Access Compliance Report

Public Rights-of-Way

Intersection ID: 45134	Main Street: DULIN_CREEK_BV	Cross Street: LITTLE_WHITEOAK_RD	Location: NW
ADA ID: DB5E9C439195	Ramp Type: BlendTrans1	Initial Pass/Fail: Fail	Overall Compliance: No
		Severity Score: 47.5

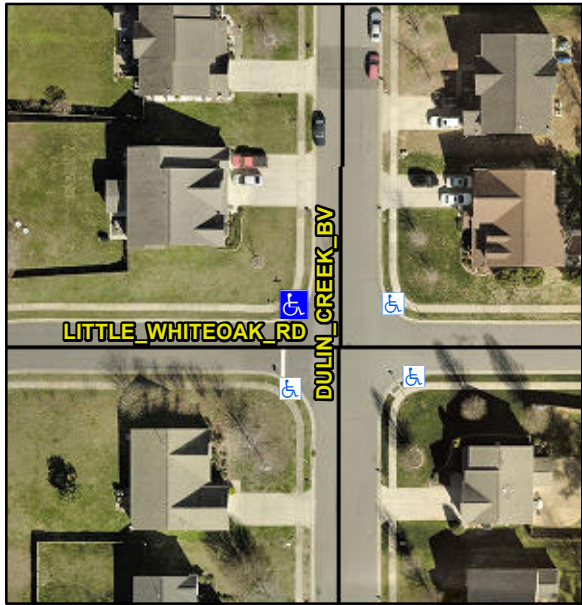
Codes/Mitigation Info/Possible Solution			Field Measurements/Component Compliance					
 <div>Street 1 Name<div>LITTLE WHITEOAK RD</div></div> <div>Stop Condition-Street 1<div>StopSign</div></div> <div>Street 2 Name<div>DULIN CREEK BV</div></div> <div>Stop Condition-Street 2<div>None</div></div>	Possible Solutions:		Compliance			Compliance		
	Remove & Replace Curb Ramp With Two New Directional Ramps or Equivalent.		N/A	Ramp Length (in)	49.5	Yes	BlendTrans Slope (%)	1.4
			No	Ramp Width (in)	30.0	No	BlendTrans XSlope (%)	5.9
			N/A	Flare Type LT	N/A	N/A	Flare Type RT	N/A
			N/A	Flare Slope LT (%)	N/A	N/A	Flare Slope RT (%)	N/A
			N/A	Flare Traversable LT?	N/A	N/A	Flare Traversable RT?	N/A
			N/A	Landing Length (in)	N/A	N/A	DWS Provided?	N/A
			N/A	Landing Width (in)	N/A	N/A	DWS Contrast?	N/A
			N/A	Landing Slope (%)	N/A	N/A	DWS Length (in)	N/A
			N/A	Landing X Slope (%)	N/A	N/A	DWS Full Width?	N/A
		N/A	Landing Curb? (Y/N)	N/A	N/A	DWS Offset (in)	N/A

N/A	Shared Landing?	N/A				
		N/A	Gutter Ponding?	N/A	N/A	Gutter Slope (%)	N/A	
		N/A	Gutter Lip Ht (in)	0.5	N/A	Gutter X Slope (%)	N/A	
		N/A	Painted X Walk1?	No	N/A	Painted X Walk2?	No	
			X Walk 1 Direction	To S		X Walk 2 Direction	To E	
			X Walk 1 Width (in)	N/A		X Walk 2 Width (in)	N/A	
			X Walk 1 Slope (%)	1.4		X Walk 2 Slope (%)	5.2	
			X Walk 1 X Slope (%)	3.7		X Walk 2 X Slope (%)	0.5	
		N/A	Ramp inside XWalk1?	N/A	N/A	Ramp inside XWalk2?	N/A	
			Road Slope (%)	3.3		Clear Space?	N/A	
			Road X Slope (%)	4.5	N/A	Clear Space to XWalk (in)	N/A	
		N/A	Any Obstructions?	N/A	N/A	Storm Grate/Utility Hazard?	N/A	
			Obstruction Type			Storm Grate/Utility Type		
					N/A		N/A	
					Yes	Surface Condition? (G/P)	Good	
					No	Curb Slope (%)	11.1

Not Found, R304.5.1, R304.5.3

Remove & Replace Curb Ramp With Two New Directional Ramps or Equivalent.
